**Re: Site Plan – Lot 1 Block A Tieszen Industrial Park Addition (Ferti Technologies Plant Renovation)**

This letter provides review comments on the submittal “Ferti Technologies – Plant Renovation, which includes certain sheets culled from a construction plan set dated 03/22/2021, as amended, namely those sheets that provide the Town with data required for a Site Plan as required by the Town’s Zoning Ordinance. Those sheets have been attached with comments included by the Town Engineer.

George Belcheff, P.E.  
Town Engineer for Ponder

STORM OUTFALL

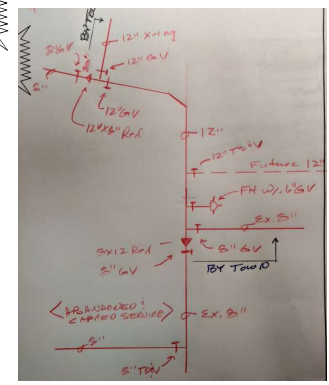
Erosion protection needed if located in channel slope

PROJECT NUMBER  
 20175.00  
 DRAWING NAME  
**UTILITY PLAN**  
 DRAWING NUMBER  
 C05.01

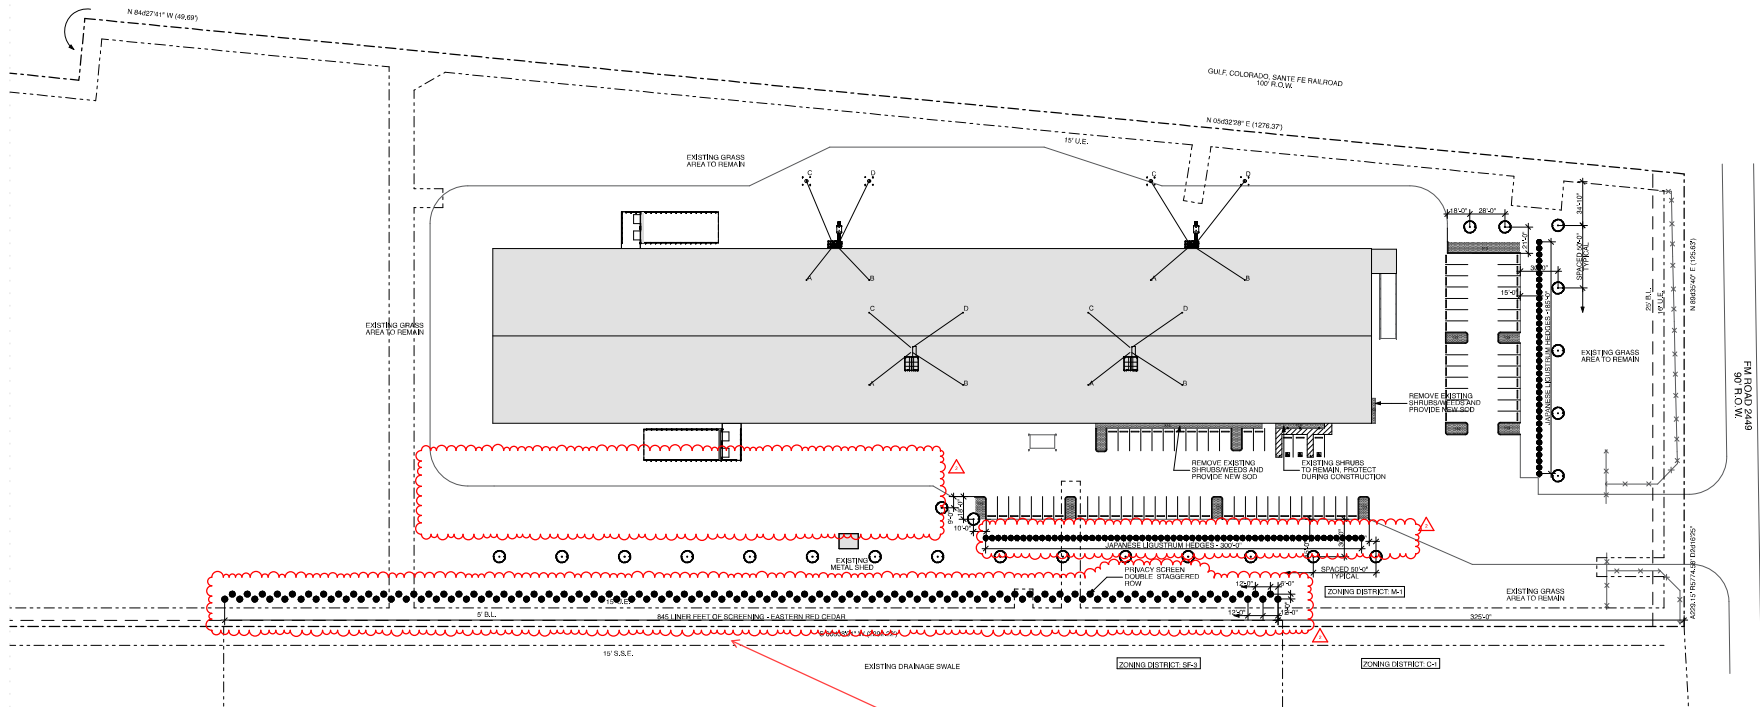
Add 1-12"x8" Red

Add 9' Water and Sewer Utility Easement

Add  
 1-12"x12"x8" Tee  
 1-8" x 12" Red  
 1-12" GV  
 1-12"x12"x8" Tee  
 1-FH W/ 8" GV

Add 10' stub-out  
 Add 2-8" GV's

Add 20' Water & Sewer Easement to existing 7 1/2' (full property length) to accommodate future 15" SS

**1**  
P.301  
**ENLARGED FIRE PUMP ROOM**  
1/2"=1'-0"

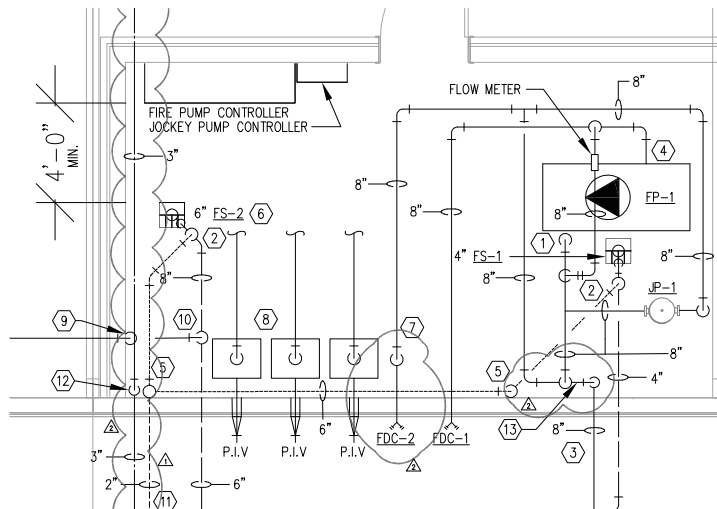
Add note to verify design flow availability determined after installation of water lines
